# Access Compliance Report

## Public Rights-of-Way

### (Curb Ramps)

Intersection ID: 23574	Main Street: CARMEL_RD	Cross Street: QUAIL_HOLLOW_RD	Location: SE
ADA ID: 120C89EF41C8	Ramp Type: Perp	Initial Pass/Fail: Fail	Overall Compliance: No
Severity Score: 12.5			
Codes/Mitigation Info/Possible Solution		Field Measurements/Component Compliance

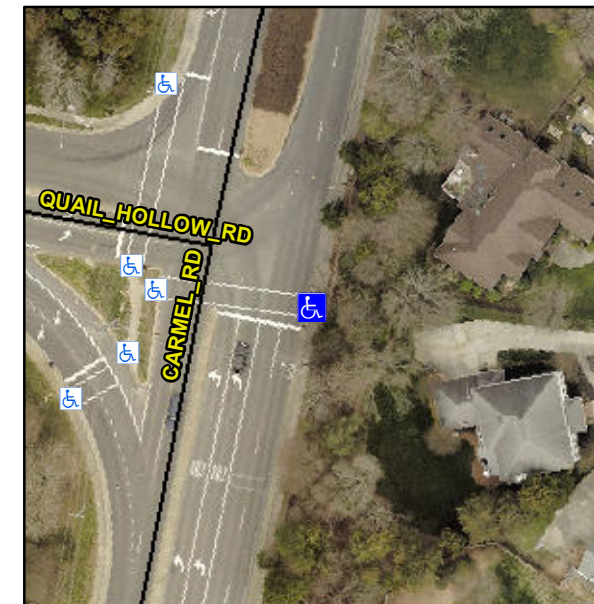
**Not Found, R304.2.2**

Compliance	Description	Data	Compliance	Description	Data
N/A	Ramp Length (in)	58.0	No	Ramp Slope (%)	11.1
Yes	Ramp Width (in)	48.0	Yes	Ramp XSlope (%)	0.8
N/A	Flare Type LT	N/A	N/A	Flare Type RT	N/A
N/A	Flare Slope LT (%)	N/A	N/A	Flare Slope RT (%)	N/A
N/A	Flare Traversable LT?	N/A	N/A	Flare Traversable RT?	N/A
N/A	Landing Length (in)	N/A	N/A	DWS Provided?	N/A
N/A	Landing Width (in)	N/A	N/A	DWS Contrast?	N/A
N/A	Landing Slope (%)	N/A	N/A	DWS Length (in)	N/A
N/A	Landing X Slope (%)	N/A	N/A	DWS Full Width?	N/A
N/A	Landing Curb? (Y/N)	N/A	N/A	DWS Offset (in)	N/A
N/A	Shared Landing?	N/A			
N/A	Gutter Ponding?	N/A	N/A	Gutter Slope (%)	N/A
N/A	Gutter Lip Ht (in)	N/A	N/A	Gutter X Slope (%)	N/A
N/A	Painted X Walk1?	Yes	N/A	Painted X Walk2?	N/A
	X Walk 1 Direction	To NW		X Walk 2 Direction	N/A
N/A	X Walk 1 Width (in)	118.0	N/A	X Walk 2 Width (in)	N/A
	X Walk 1 Slope (%)	2.1		X Walk 2 Slope (%)	N/A
	X Walk 1 X Slope (%)	0.1		X Walk 2 X Slope (%)	N/A

**Remove & Replace Entire Ramp.**
